UNITED STATES
DEPARTMENT OF THE INTERIOR
BUREAU OF LAND MANAGEMENT
SUNDRY NOTICES AND REPORTS ON WELLS

Bison Wallow Unit 1

30-015-23112

PROPOSED P&A

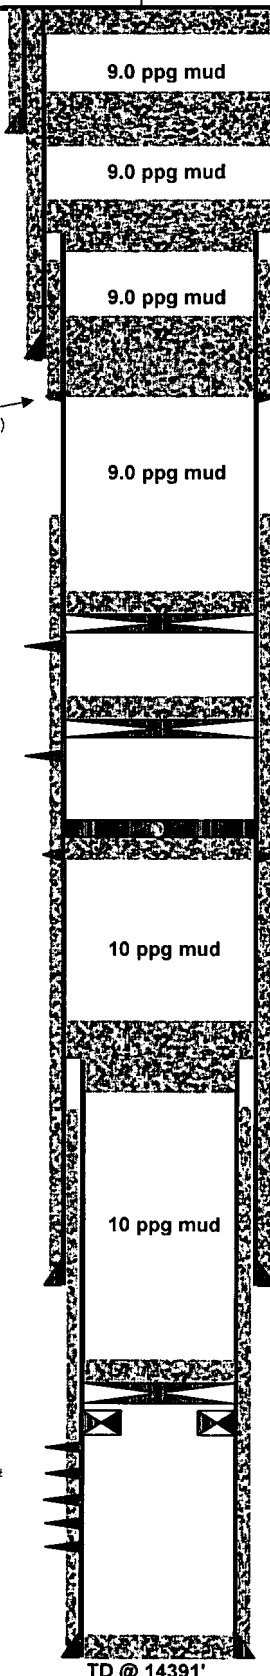
*Step #2 NMOC requires top of Delaware
be cemented. Top of Delaware 3050'.
Plug should extend to 3100'.*
